PARTS & SERVICE NEWS

REF NO.	AA04081
DATE	June 9, 2004

SUBJECT: INTRODUCE AN IMPROVED ELECTRIC HORN

PURPOSE: To introduce a new electric horn with an improved sound quality and its installation procedures for use on wheel loaders listed.

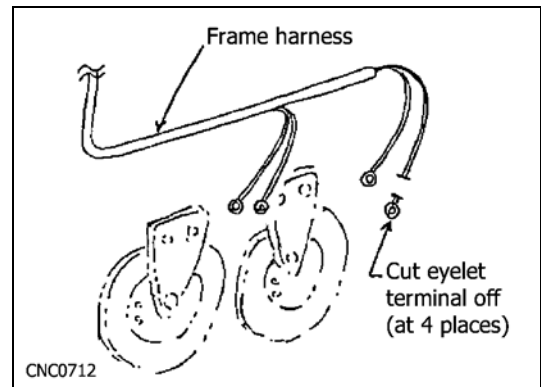
- Remove the current horn being installed to the location shown in the schematic diagrams given below. Meanwhile, keep the mounting bolts since they will be reused.

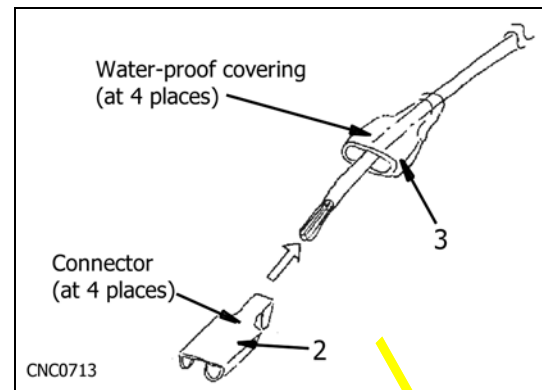
- Rework the harness terminal. Disconnect the terminals connecting to the horn (eyelet terminals, at 4 places) and cut off the eyelet terminal.

- First, insert the waterproof cover through a lead from which the eyelet terminal has been removed. Now, caulk the new connector over the lead.

- Next, push the waterproof cover back until it covers the caulked connector totally. This completes the terminal installation. Repeat the above with remaining three leads.

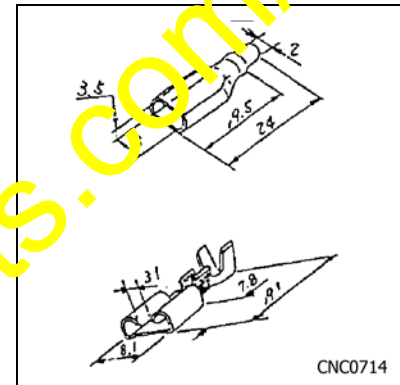
- Install the new horn kit (Hi and Lo) according to the schematic diagram given at right, and connect the reworked terminals.
